# DAM SAFETY INSPECTION REPORT

Sippo Creek Reservoir Dam  
Class I  
Stark County, Perry Township  
File Number: 0614-012  
February 21, 2006

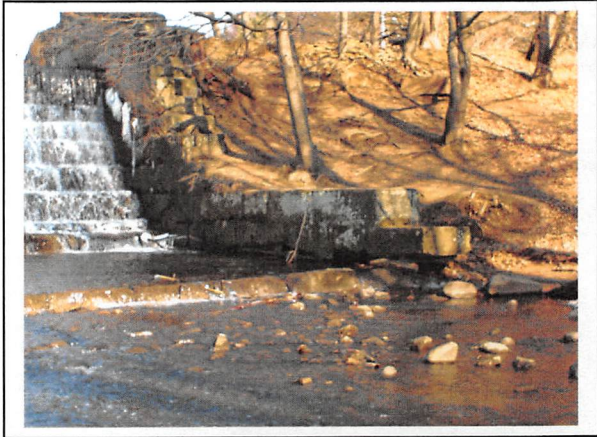
View of the brick cut-off wall across the right half of crest and the downstream slope.

View of the brick cut-off wall across the left half of crest. The blue arrow indicates where bricks have become displaced from the wall.

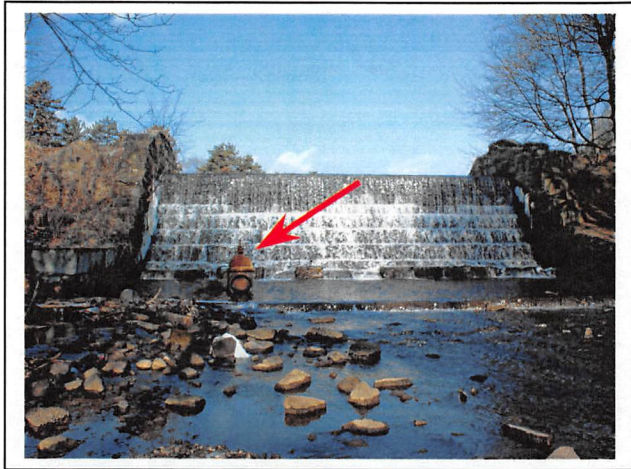
View of the right downstream slope. The red circles indicate the locations of planter boxes on the slope, and the blue lines indicate the location of erosion gullies on the slope.

View of the left downstream slope. Note the lack of vegetal ground cover and the trees on the dam.

2. Repair the erosion gullies on the right side of the downstream slope near the principal spillway sidewall. See the "Ground Cover" fact sheet included in this section for additional information.
3. Remove the flower planters from left and right half of the downstream slopes. See the "Earth Dam Failures" fact sheet

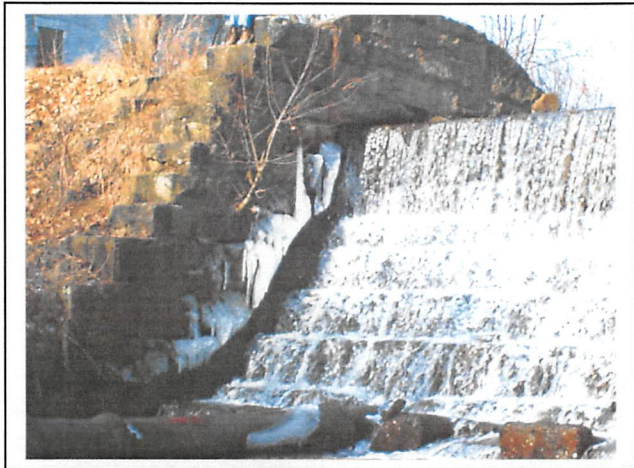
View of the hand placed masonry block principal spillway. The red arrow points to the lake drain pipe and valve.

4. The lake drain must operate properly. Investigate the integrity of the drain, and as necessary, prepare plans and specifications for the repair or replacement of the lake drain. See the "Lake Drains" fact sheet included in this section for additional information.

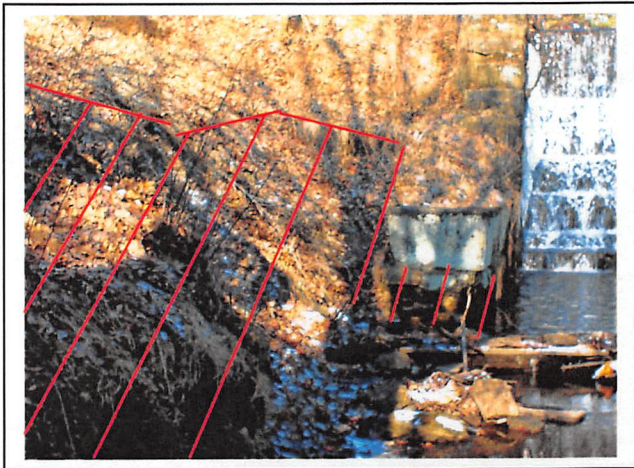
View of the interior right principal spillway side wall. Note the ice from seepage through the joints in the wall. Also note the sapling growing from out of the wall.

3. The entire spillway system must be repaired. Prepare plans and specifications for repair of the seepage through the sidewalls, the undermining of the upstream and downstream end of each sidewall, the loose and missing stones that comprise the spillway, the erosion around the sides of the apron of the spillway, and proper outlet erosion protection. The condition of the spillway system must be monitored for further deterioration. See the "Open Channel Spillways (Concrete Chutes and Weirs)", the "Outlet Erosion Control Structures (Stilling Basins)", and the "Seepage Through Earthen Dams" fact sheets included in this section for additional information.

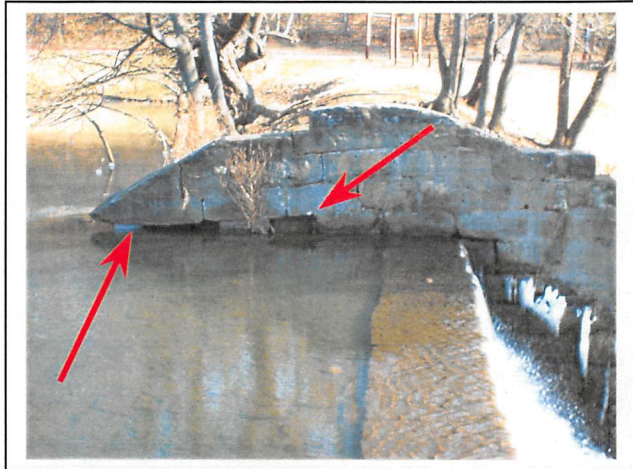
View of the downstream end of the right side wall. The red hatched area indicates erosion. Note that it is eroded behind and under the end of the wall.

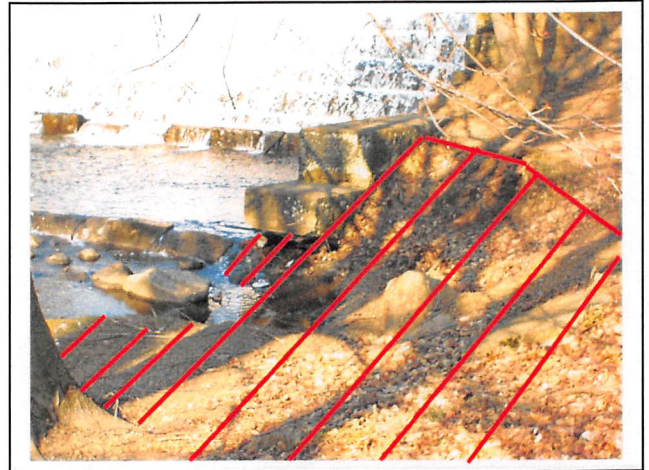
Interior view of the left upstream end of the principal spillway sidewall. The arrows indicate undermining of the wall and missing stones. Also note the seepage emerging from the side wall through unsealed joints.

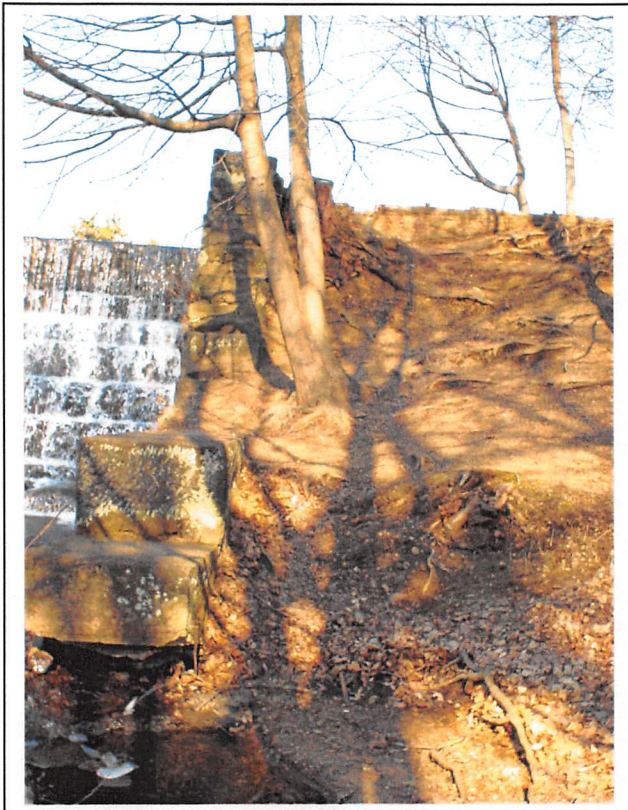
View of the downstream side of the left side wall. The hatched lines indicate erosion under and behind the side wall.

Other views of the undermining and erosion at the downstream end of the left side wall.
